Re: Initial Submission Review: The Aurora Highlands PA-58 Neighborhood Park – Site Plan and Final Plat
Application Number: DA-2062-56
Case Numbers: 2024-6011-00; 2024-3016-00

Initial Submission Review

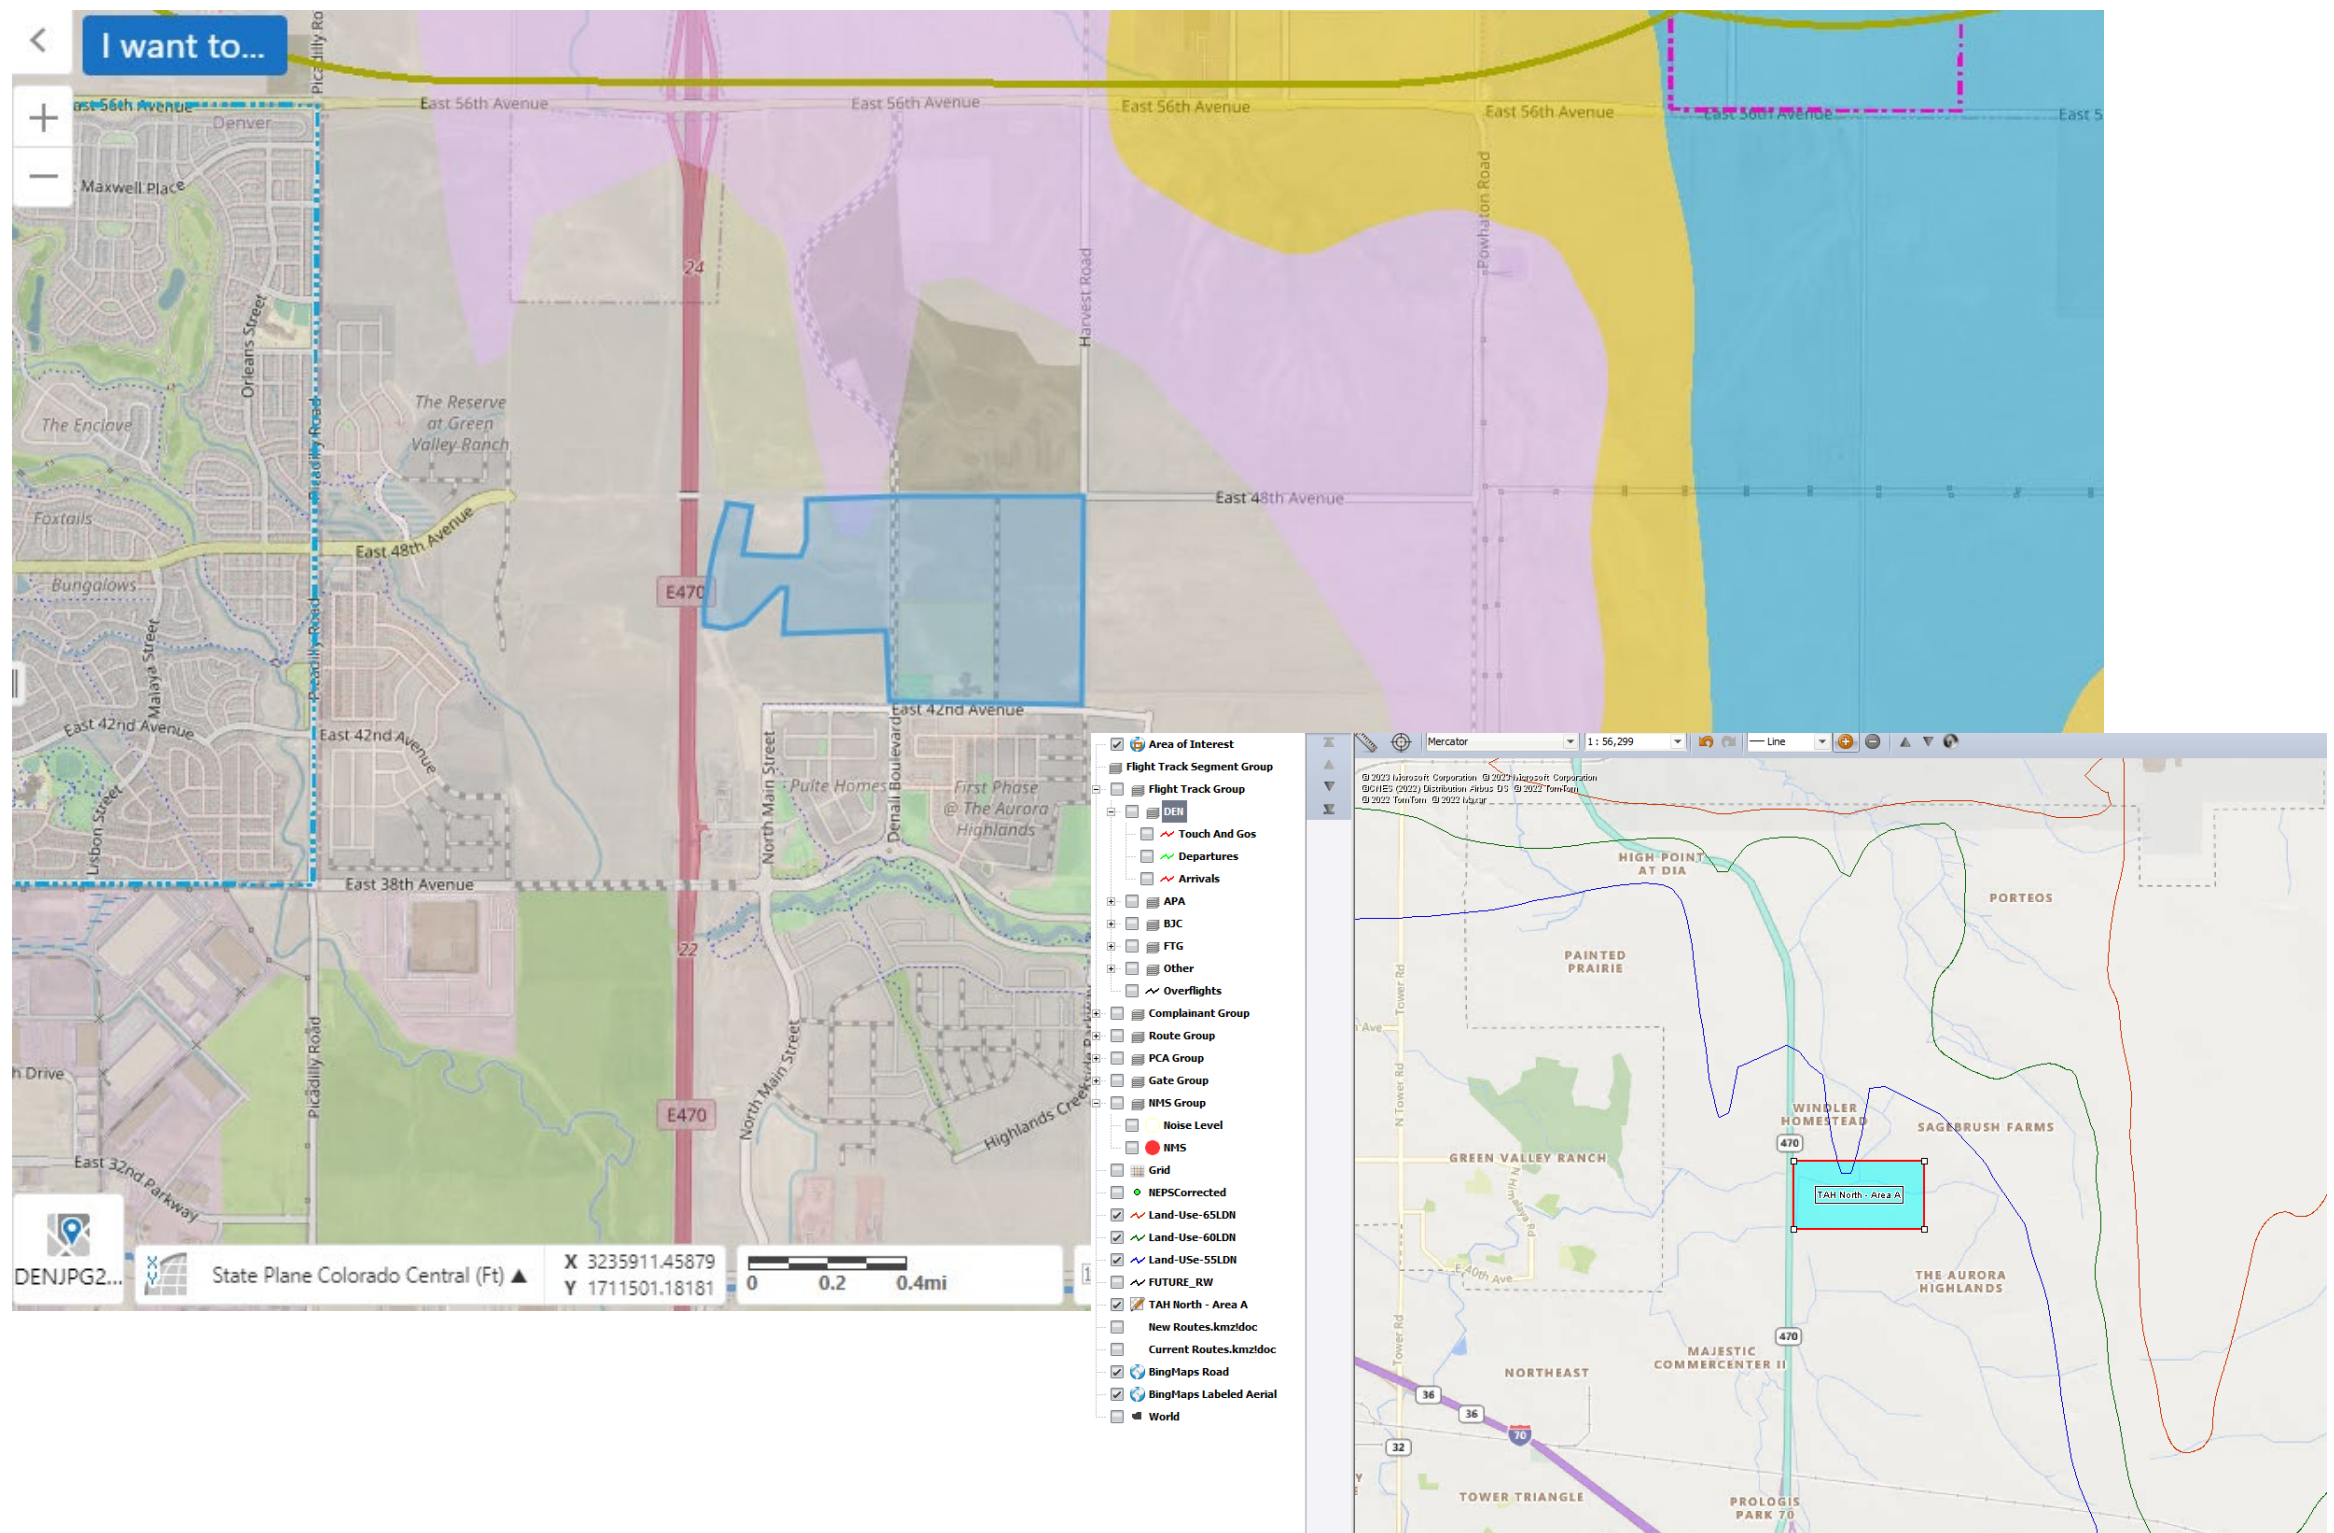
Public Service Company of Colorado's (PSCo) Right of Way & Permits Referral Desk has reviewed the site plan for **The Aurora Highlands PA 58 Neighborhood Park**. For future planning and to ensure that adequate utility easements are available within this development and per state statutes, PSCo requests 10-foot-wide utility easements around the perimeter of this tract.
